PIC16(L)F19155/56/75/76/85/86

PIC16(L)F19155/56/75/76/85/86 Family Silicon Errata and Data Sheet Clarifications

The following typographic corrections and clarifications are to be noted for the latest version of the device data sheet (DS40001923B):

FIGURE 1: 28-PIN SSOP, SPDIP AND SOIC PIN DIAGRAM FOR PIC16(L)F19155/56

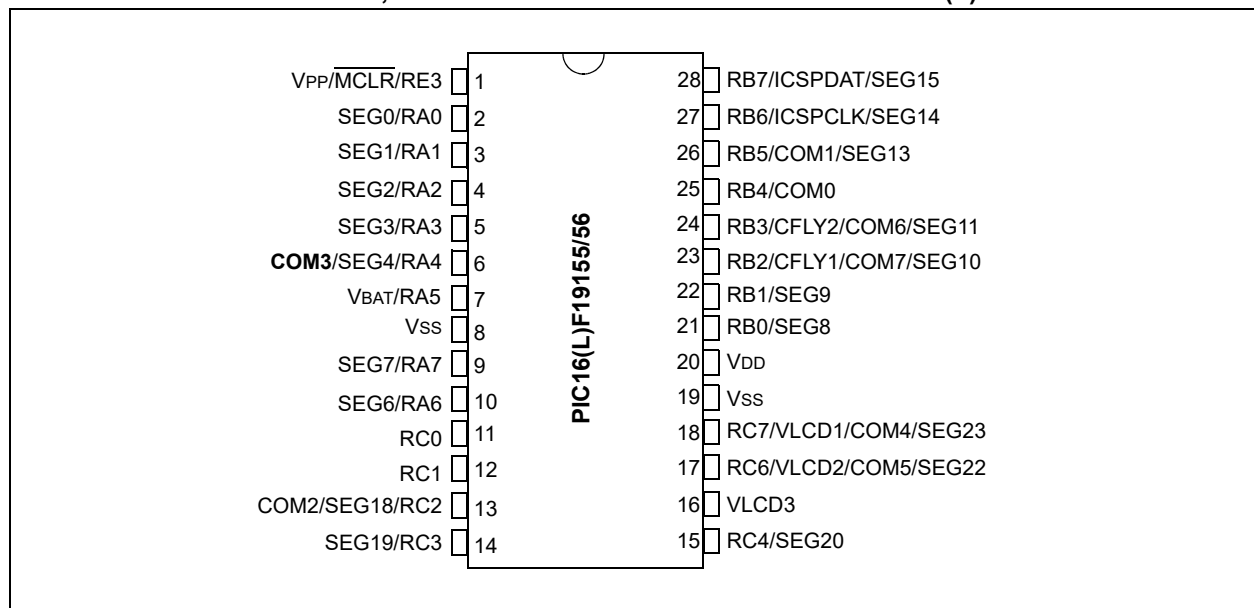
2.1 Pin Diagrams, Figure 1

The COM0 function multiplexed to RA4 is changed to COM3, as shown below.
